VISION RANGE HONEYWELL VK GAS VALVE NOTIFICATION

Fig.3
Honeywell VK4105C(A)
AmbiRad no. 202658 (202657)

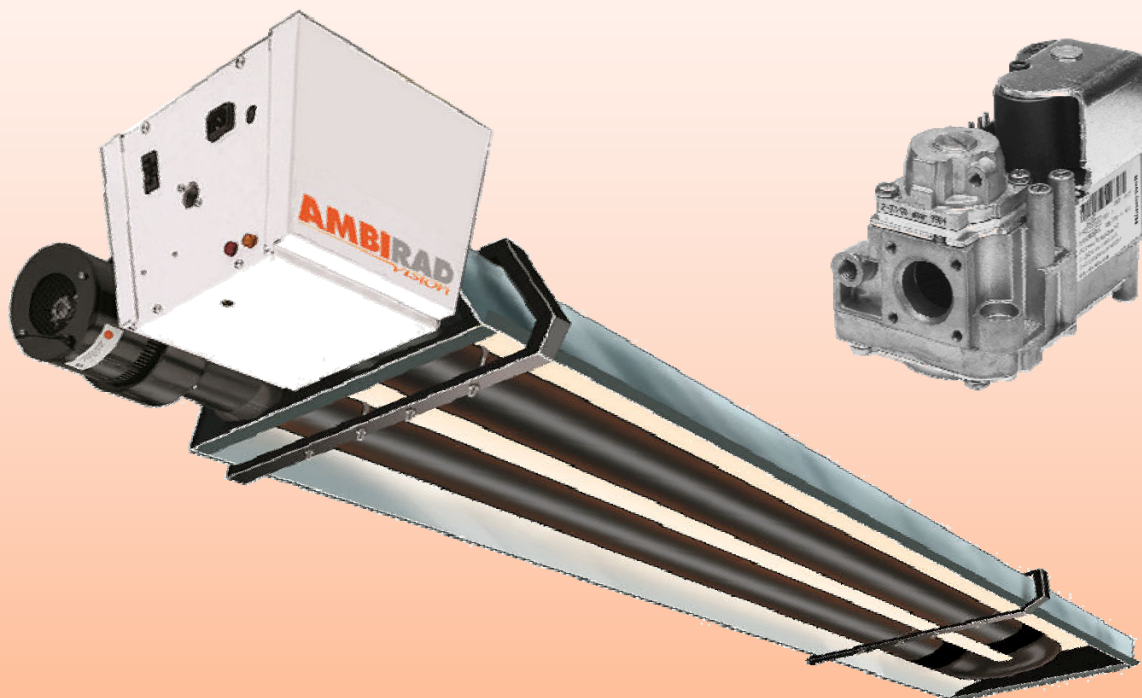
Due to on-going improvements, the gas valves fitted to the Vision range of radiant heaters are being changed from the current SIT valve (Fig.1) and White Rodgers (Fig.2), to the new Honeywell valve (Fig.3). The new valves are suitable for Natural gas part no. 202658 and Propane part no. 202657.

Burners fitted with the new Honeywell valve will be labelled with generation code: AB so that the valve can be identified for spares purposes. Example burner label shown below:

For spares purposes: Only Vision burners currently fitted with White Rogers gas valves part Nos. 202404 and 202528 with generation code 'AA' can be replaced with the new Honeywell gas valves.

Note: Vision burners currently fitted with SIT 840 Sigma Gas Valves part no's. 201857 and 201914 can **NOT** be replaced with the new Honeywell gas valve. SIT valves will be made available as spares.

A kit of parts has been created for replacement spares. This kit will take form of the valve, mini valve harness, rubber spacer and two off M4 x 10 Screws. Part number for Natural Gas valve kit replacement is **202748** and part number for Propane Gas valve Kit replacement is **202749**.
